**RE: Lot 21 Block 1 Unser Cliffs SAD 227
6905 Rimrock NW
Grading and Drainage Plan
Engineers Stamp Date 6/15/17 (D10D008)
Pad Certification Date 7/12/17**

Based upon the information provided in your submittal received 7/12/17, this plan is approved for Building Permit.

ENGINEER'S SEAL	6905 RIM ROCK CIRCLE MAXWELL RESIDENCE	DRAWN BY WCWJ
	GRADING AND DRAINAGE PLAN	DATE 6-14-17
	 <div data-bbox="2652 1892 2722 1931"> <i>Rio Grande Engineering</i> 1606 CENTRAL AVENUE SE SUITE 201 ALBUQUERQUE, NM 87106 (505) 872-0989 </div>	21750-LAYOUT-6-14-17
		SHEET # —
6/15/17	 <div data-bbox="2652 1892 2722 1931"> <i>Rio Grande Engineering</i> 1606 CENTRAL AVENUE SE SUITE 201 ALBUQUERQUE, NM 87106 (505) 872-0989 </div>	JOB # 21750
DAVID SOULE P.E. #14522

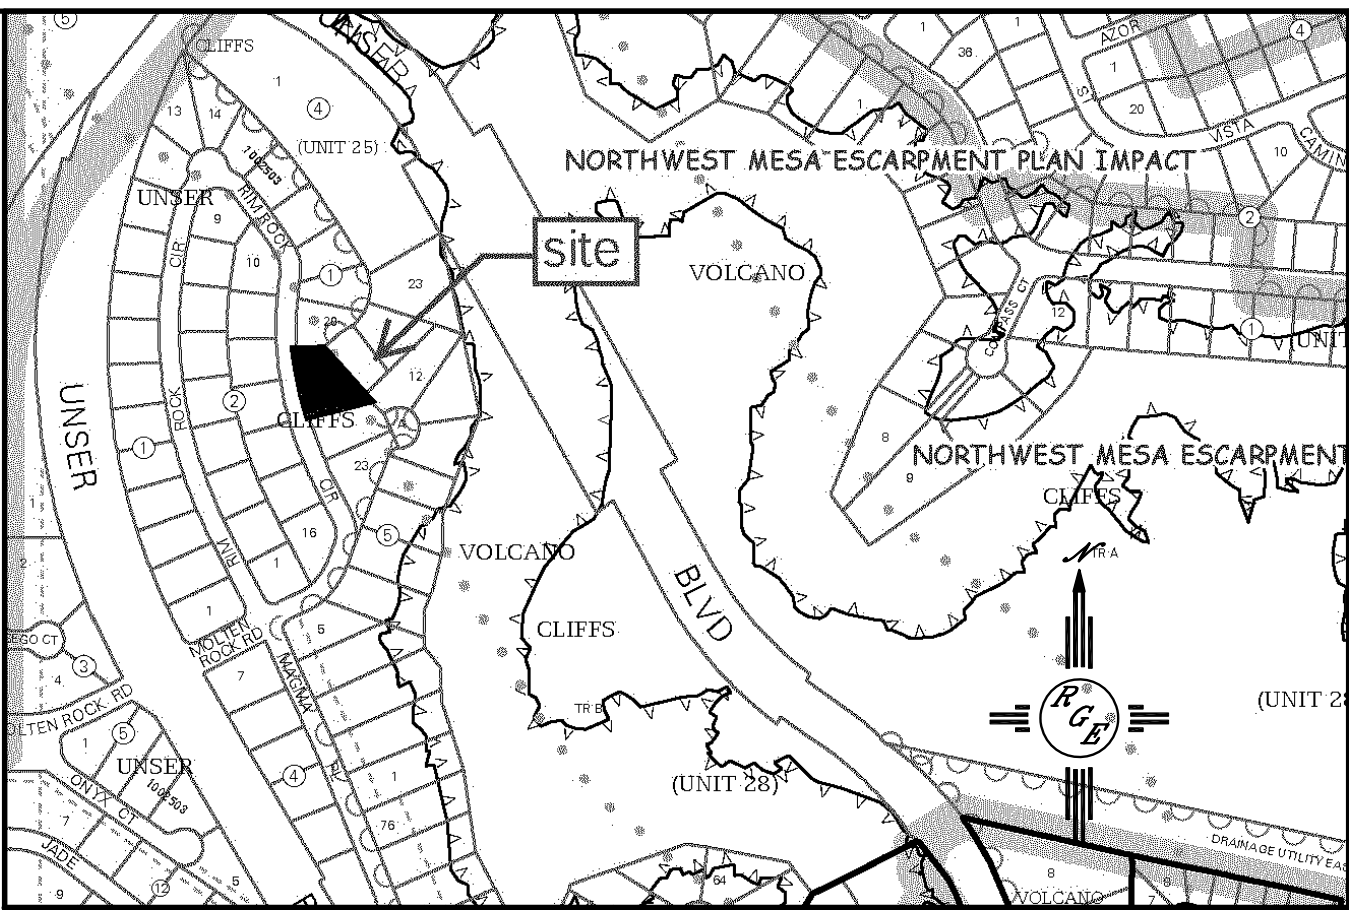
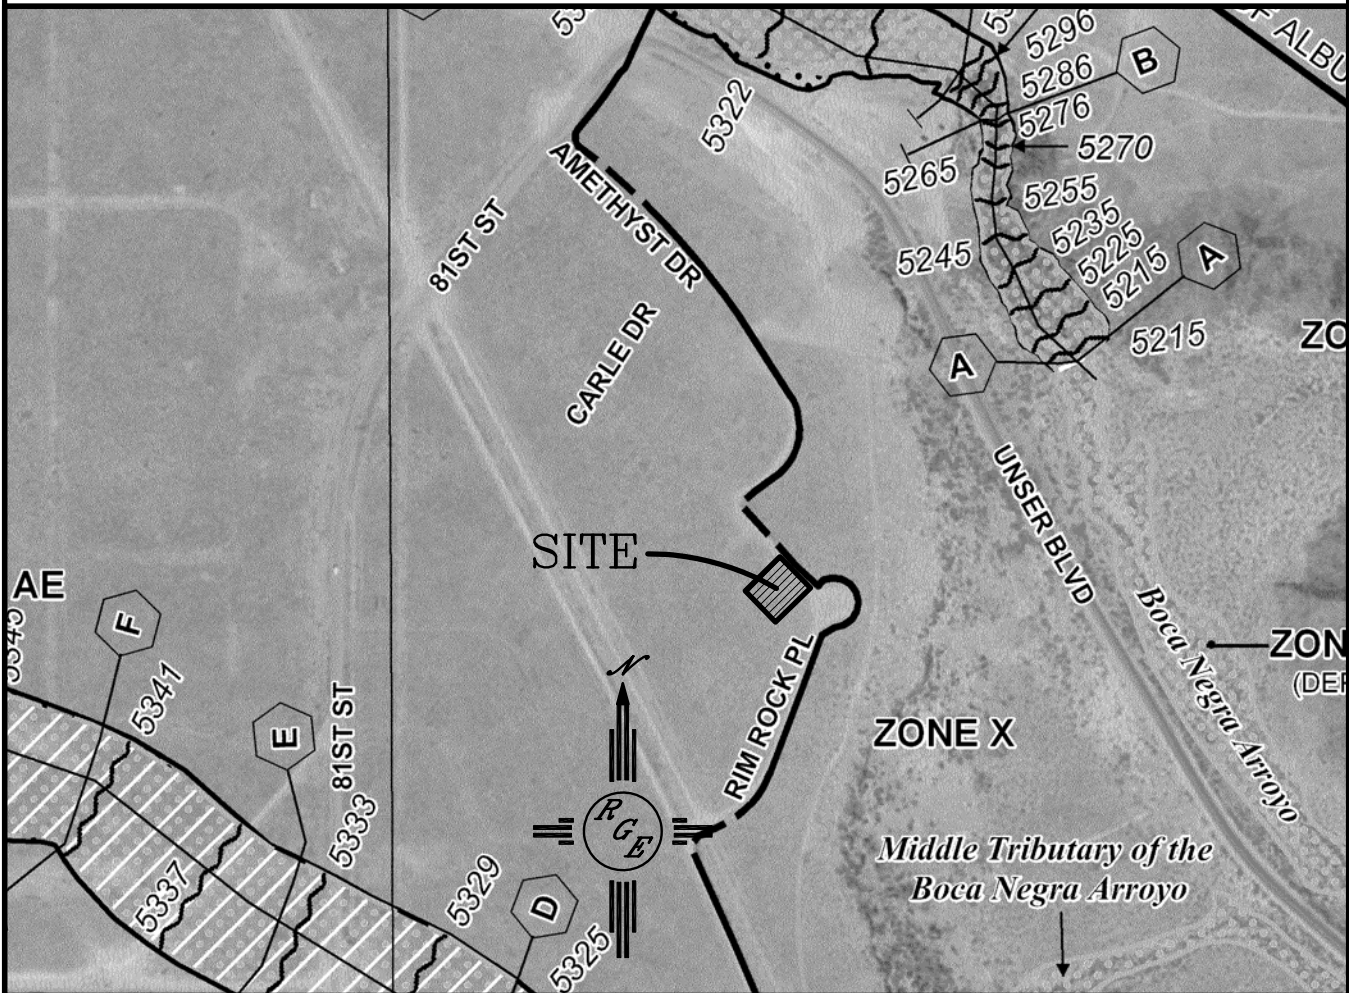
Please inform the builder/owner to attach a copy of this approved plan to the construction sets in the permitting process prior to sign-off by Hydrology. Reiterate to the Owner/Contractor that a separate permit for a garden/retaining wall must be obtained, with the approved G&D plan dated 6/15/17.

Prior to Certificate of Occupancy release, Engineer Certification per the DPM checklist of this plan will be required.
